**MODIFICATION REQUEST:  
CASUARINA TOWN CENTRE  
TWEED COAST ROAD, CASUARINA  
06\_0258 MOD 5**

Director-General's  
Environmental Assessment Report  
Section 75W of the  
*Environmental Planning and Assessment Act 1979*

September 2013

**Figure 5:** Plan of proposed retaining wall and associated works (Source: Newton Denny Chapelle)

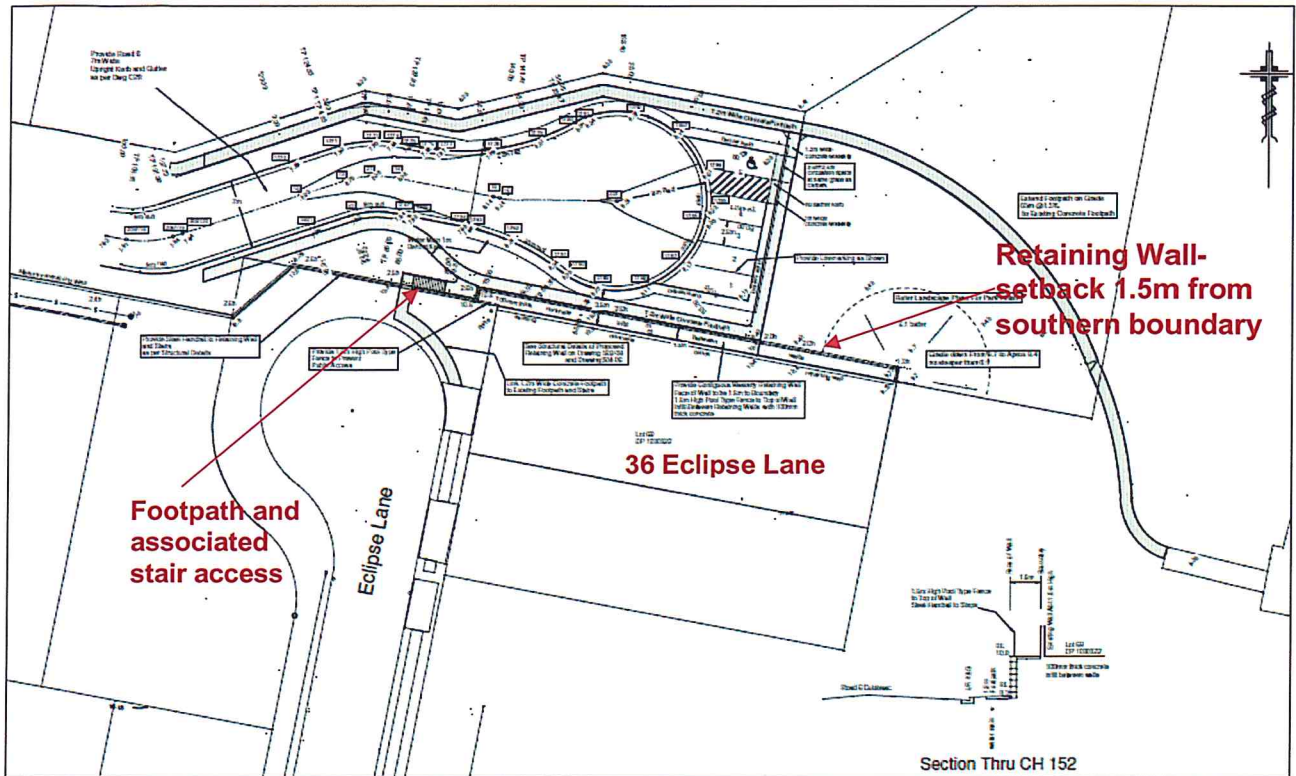
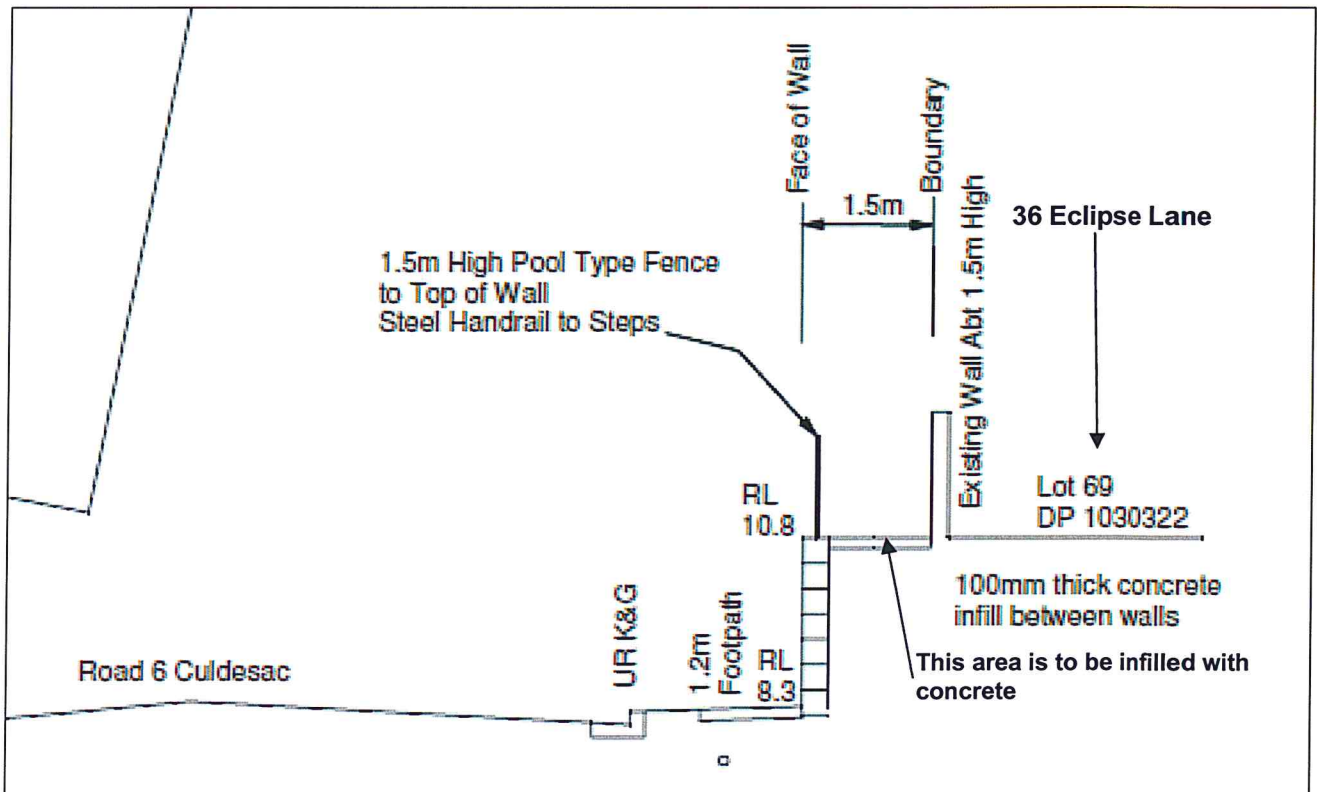
c	The retaining wall should be relocated to the northern side of Road 6 OR the retaining wall placed 4-5 metres away from the southern boundary.	The relocation of the retaining wall to the northern side of Road 6 would require significant changes to the civil design. Given the levels proposed in the modification application are generally consistent with the Project Approval, substantial changes to the civil works are unwarranted in this instance.
d	The concrete capping and pool fencing is unacceptable. The design will make maintenance difficult. The design should use stainless steel wire fencing and to 1.5m at least 4-5 metres from the boundary and the area should be planted, consistent with the rest of the town centre.	The retaining wall will be dedicated to council on completion of construction. Council has raised no objection to the design. The concrete infill between the pool fencing and the boundary fence will minimise ongoing maintenance requirements, and is considered to be appropriate in the circumstances.

As detailed in section 4.2, the neighbouring land owner at 36 Eclipse Lane has raised concerns in relation to the design of the retaining wall, including the location of the wall. The modification application seeks approval to locate the retaining wall 1.5 metres off the southern boundary of the site and furthermore, to install a pool type fence on the northern edge, for safety reasons. The retaining wall is proposed to be surfaced in a shotcrete finish. As illustrated in **Figures 5 and 6**, the area between the retaining wall and the boundary fence of No.36 Eclipse Lane is to be infilled with concrete.

Council has raised no objection to the proposed design. As Road 6 and the surrounding land to the southern boundary will be dedicated to Council, Council has advised that the infill area between the boundary wall and the new fence is not to be landscaped in order to minimise ongoing maintenance requirements and furthermore, that the concrete infill is to be provided with a grade of 1%, falling towards the face of the retaining wall. Council has also advised that the area is to be provided with a lockable gate, to allow future access for maintenance.

The department has considered the design options provided by the proponent and furthermore, the concerns raised in objections. As stated above, an engineering solution which suitably retains the excavated land is required. The construction of a retaining wall is a practical and appropriate solution and therefore, the design is considered to be acceptable in the circumstances. Whilst concerns have been raised by the landowner of No.36 Eclipse Lane in respect to safety (i.e. potential for a person to fall off their boundary fence past the retaining wall and fall to the road below) the 1.5 metres setback and the inclusion of the pool fence at the top of the retaining wall has suitably resolved this issued. It is noted that in the approved construction certificate (CC13/007), the retaining wall was directly on the boundary to No. 36 Eclipse Lane.

Subject to the final construction details complying with the requirements of Council, the department raises no objection to the design of the retaining wall. The design requirements of Council are recommended in new condition B2(5).

- **New Condition B2(5)** – as detailed in Section 5.2, Council has recommended that the final design for the retaining wall incorporate a locked gate and furthermore, that the concrete infill be design with a grade of 1%. New Condition B2(5) is recommended to address these requirements.

**Figure 7:** extract from approved plan DA105 (MOD 2)

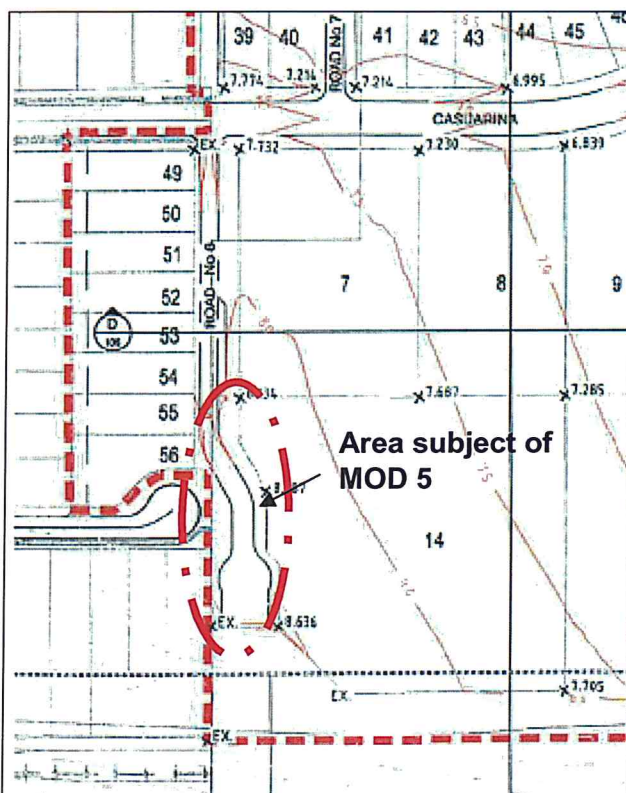
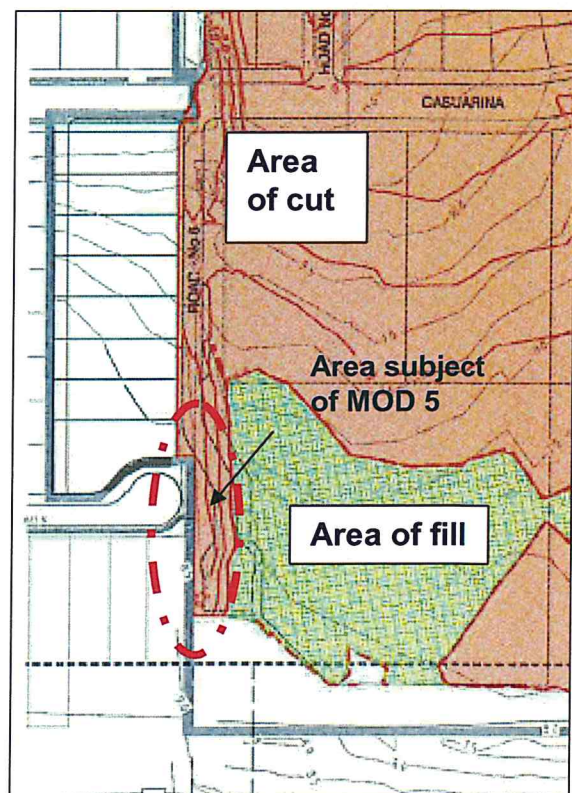
As detailed in Section 1.2 above, MP 06\_0258 MOD 2 included an amendment to the extent of approved cut and fill on the site. An extract of the approved plans, showing the levels relative to the south-east corner of the site are provided at **Figures 7** and **8** below. These plans illustrate that there would be cut relative to the southern boundary for the road construction to reconcile with the existing level of RL8.6 at the southern end of the cul-de-sac head of Road 6.

CC13/007 issued for the Stage 1A works (including the bulk earthworks), generally accords with the levels illustrated in **Figures 7** and **8**. Whilst insufficient details were shown on the application drawings accompanying MOD 2 to indicate that a retaining wall was required along the southern boundary of the site (the department notes that this was not identified on any plan), it is relevant and appropriate that an engineered solution be constructed to reconcile these new land levels with those existing at the boundary.

In this instance, the department is satisfied that the construction of the retaining wall is the most appropriate and practical solution without significantly altering the subdivision layout (as approved). The department is also satisfied that the proponent has given sufficient consideration to alternative options to reconcile the level changes and notes that Council has raised no objection to the proposal.

**Figure 9:** Extract from amended Plan C56 Rev 6 showing relocated access stair (Source: Newton Denny Chapelle)

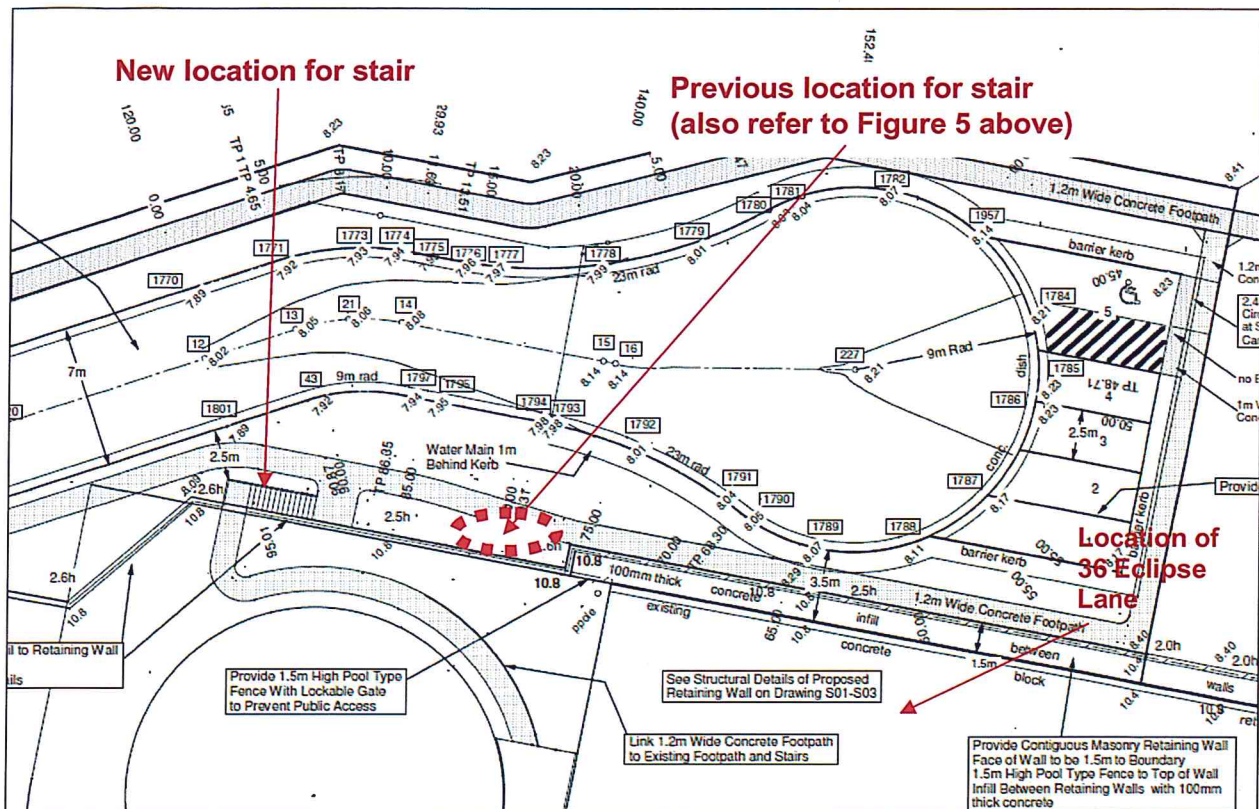
e	The steps should be relocated to the western side of the courtyard to accommodate the majority of the pedestrian traffic.	The department concurs with these comments. The proponent has agreed to locate the stairs to western side of the cul-de-sac. A revised plan has been submitted to address this matter. Refer to further discussion in section 5.2 below.
f	The current proposal will require pedestrians to use the footpath and deteriorating footbridge in front of our property raising concerns regarding noise, safety and security.	The design of the pathway connecting to the footbridge to the east is consistent with the design shown on the Concept Approval and Project Approval drawings and does not form part of this modification application.
g	The retaining wall is not in keeping with the natural landscape of the Casuarina beachfront.	Refer to comments at Point 3d above.
h	There does not need to be any retaining wall in front of the property. There is plenty of fill to provide for natural contouring across the site.	The levels proposed to be constructed are generally consistent with the Project Approval. For this reason, it is considered inappropriate that the civil works be redesigned to provide for the graduation of the land contours.

Concern has been raised in public submissions in relation to the location of the stair and the potential for its use to impact on the amenity and safety of neighbouring properties i.e. given its proximity to these properties. The department concurs with the concerns raised in submissions and considers that these impacts could be mitigated by relocating the stair further to the west of its current locations. Following further consultation with the department, the proponent has agreed to relocate the stair to the western side of Eclipse Lane as illustrated in **Figure 9**.

Council has been consulted in relation to this design amendment and has raised no objection. On this basis, the department considers the amended design to be acceptable.
